PRODUCT/PROCESS CHANGE NOTICE (PCN)

PCN #: A1403-01 DATE 3-Apr-2014		MEANS OF DISTINGUISHING CHANGED DEVICES: ☐ Product Mark ☒ Back Mark Lot# will have a "A" prefix to denote alternate site, OSE Taiwan. ☐ Date Code ☐ Other
Product Affected: SOIC-28 Refer to Attachment II for the affected part numbers		
Date Effective: 3-Jul-2014		
Contact: IDT PCN DESK	Attachment: ☒ Yes ☐ No	
E-mail: pcndesk@idt.com	Samples: Please contact your local sales representative for sample request & availability.

ATTACHMENT I - PCN # : A1403-01

PCN Type: Manufacturing Site - Alternate Assembly Location

Table 2: Comparizon of Package Outline Dimensions on the Existing Assembly and Alternate Assembly

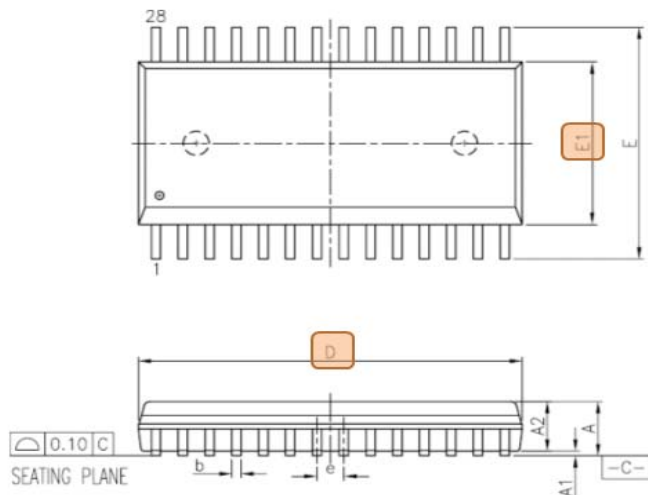
There are minor changes on the package dimensions as shown in Table 2.

POD SYMBOL	Unisem mils	OSE mils	Jedec mils	Remarks
D (body length)	718~728	697~733	697~733	No impact to design board footprint
E1 (body width)	340~350	324~350	324~350
